Addendum No. 5

DATE: Wednesday, July 10, 2019

PROJECT: City of Pharr/PSJA Aquatic Facility

PROJECT NO: 971805/ 1819-35-510-C011-051

A1.01 ADD5
SITE PLAN

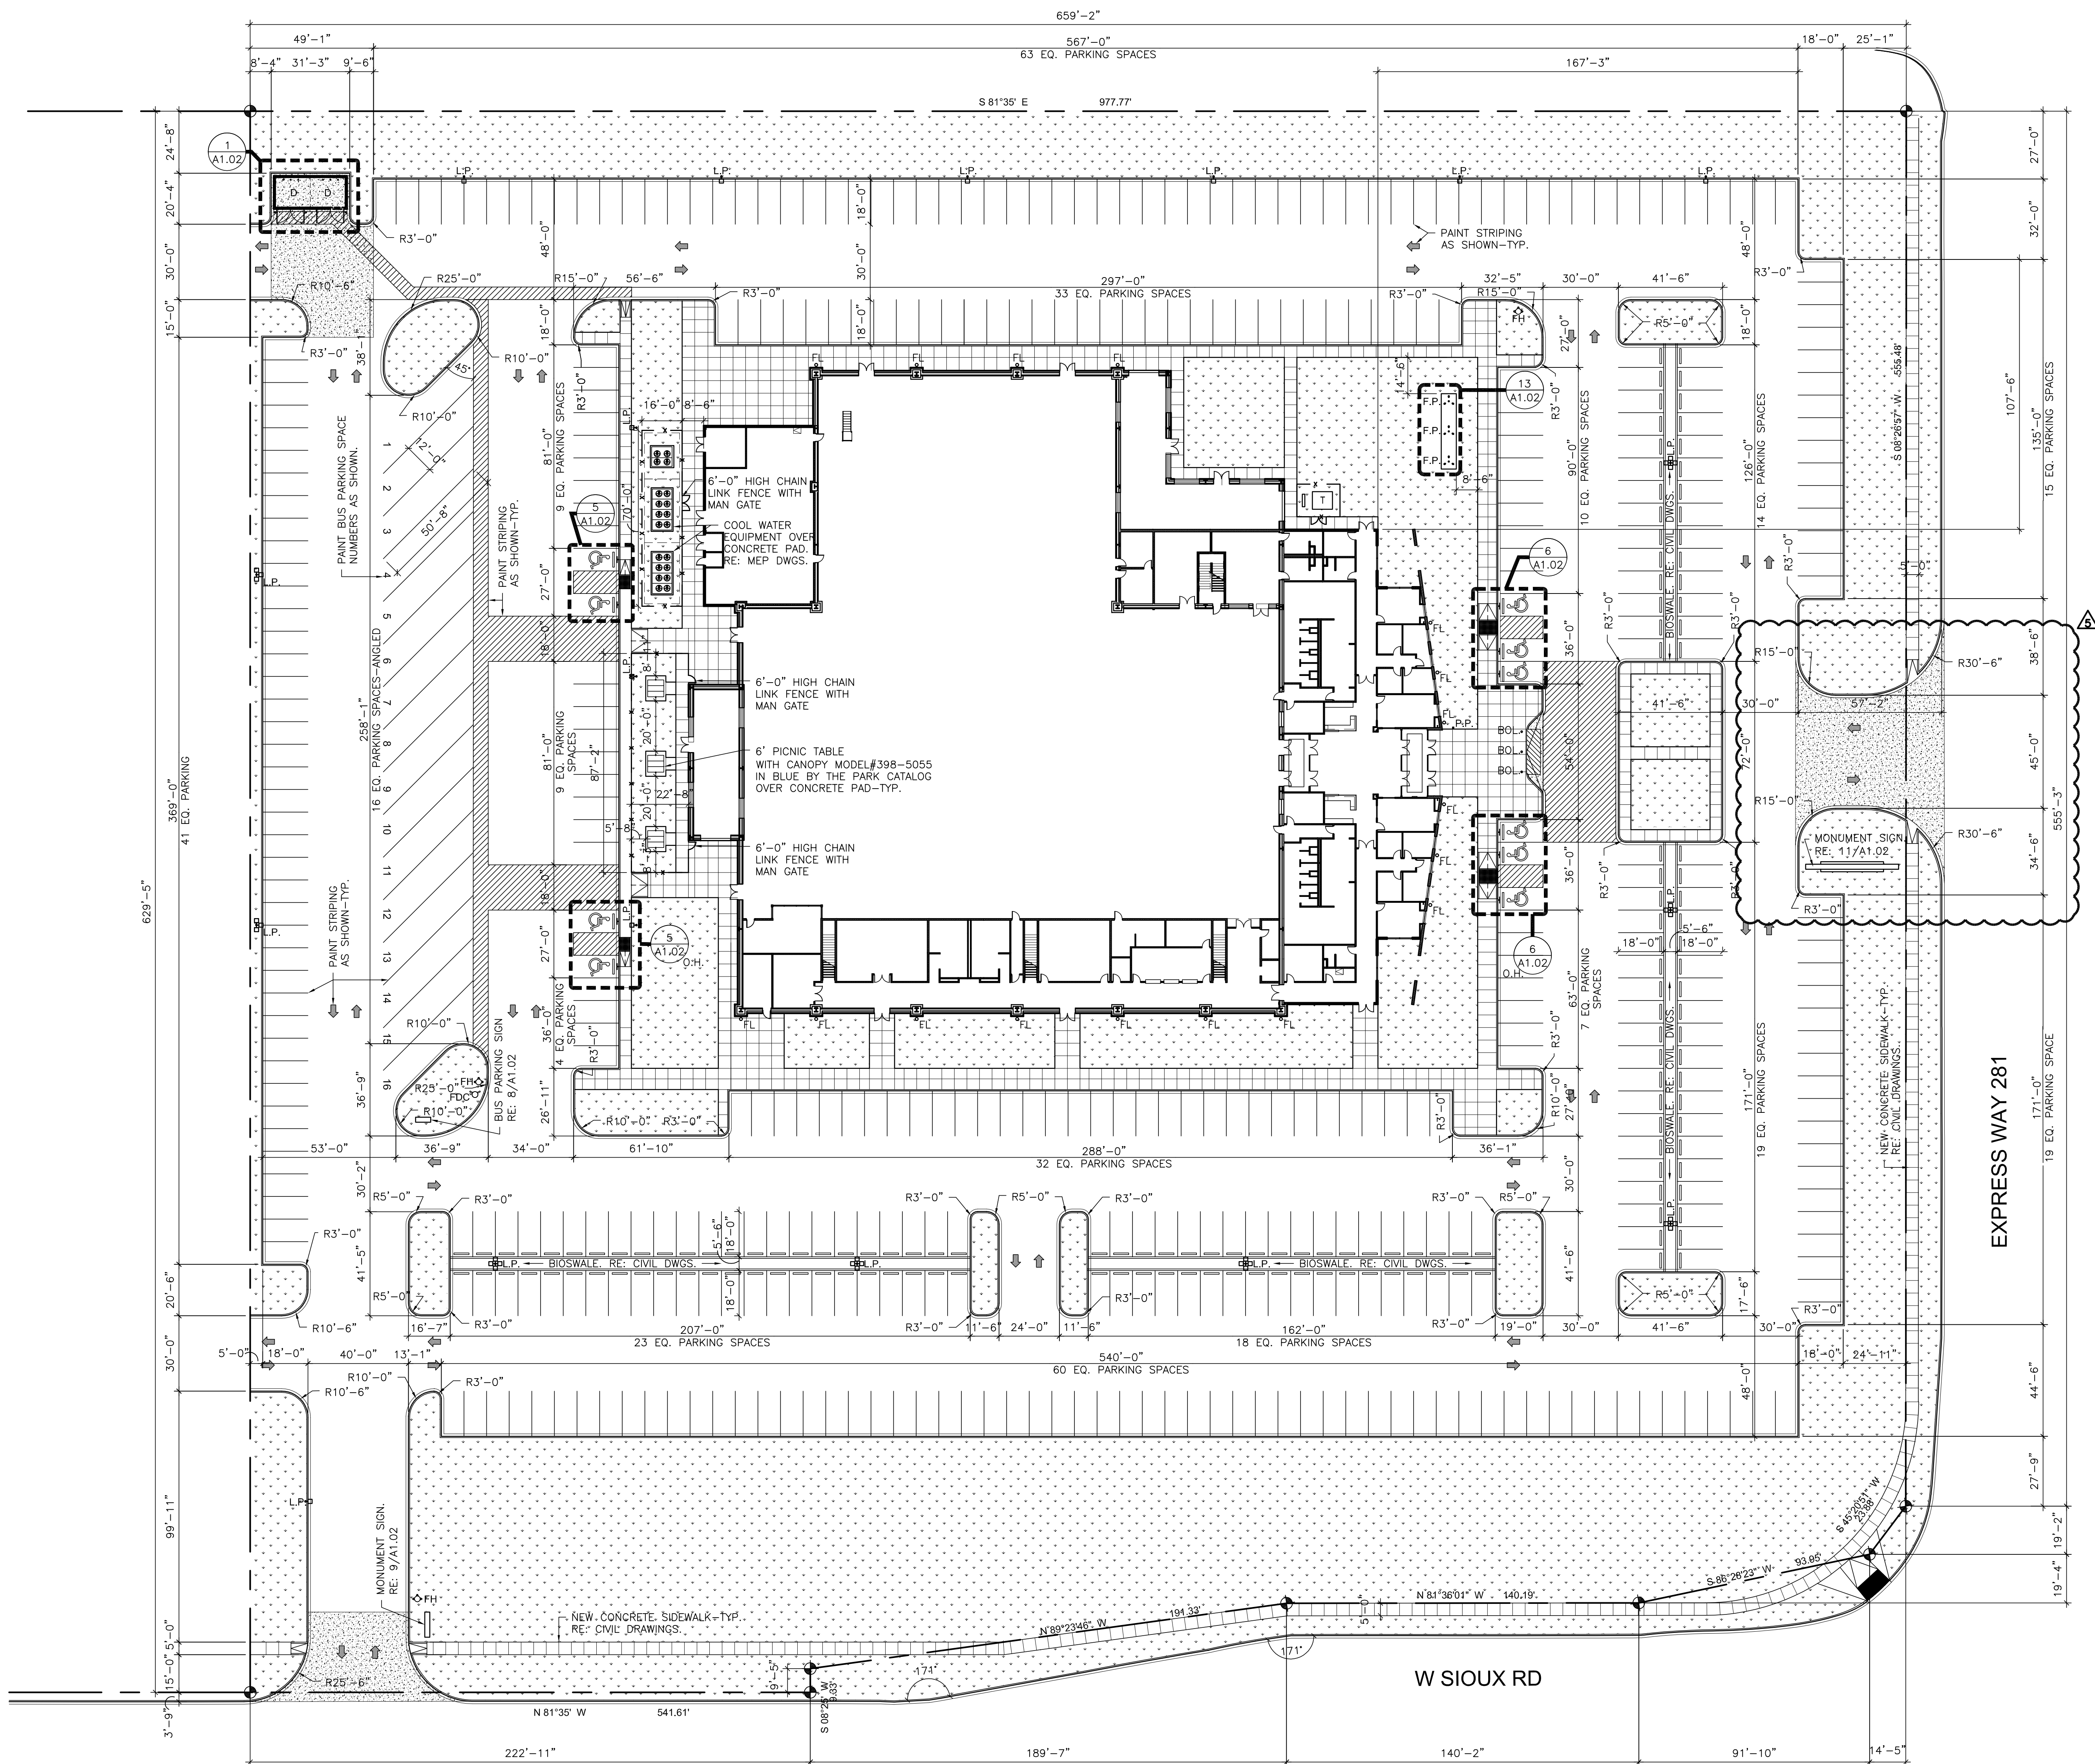
PDF Format – 8.5"x11" Geotechnical Engineering Study dated 3/6/2019
PDF Format – 8.5"x11" Section 08 71 00 Door Hardware ADD5 dated 07/10/2019
PDF Format – 8.5"x11" Section 13 11 00 Swimming Pools ADD5 dated 07/10/2019
PDF Format – 8.5"x11" Section 13 11 00 Swimming Pools Timing System ADD5 dated 07/10/2019
PDF Format – 8.5"x11" CSI Form-Solid Plastic Lockers dated 6/26/2019
PDF Format – 8.5"x11" CSI Form-Fluid Applied Weather Barriers dated 07/08/2019
PDF Format – 8.5"x11" CSI Form-Vapor Barrier dated 07/08/2019
PDF Format – 8.5"x11" CSI Form-Coiling Service Door and Coiling Counter door dated 07/08/2019
PDF Format – 8.5"x11" ADD-4-01
PDF Format – 30"x42" G0.01 ADD 5 dated 07/10/2019
PDF Format – 30"x42" A1.01 ADD 5 dated 07/10/2019
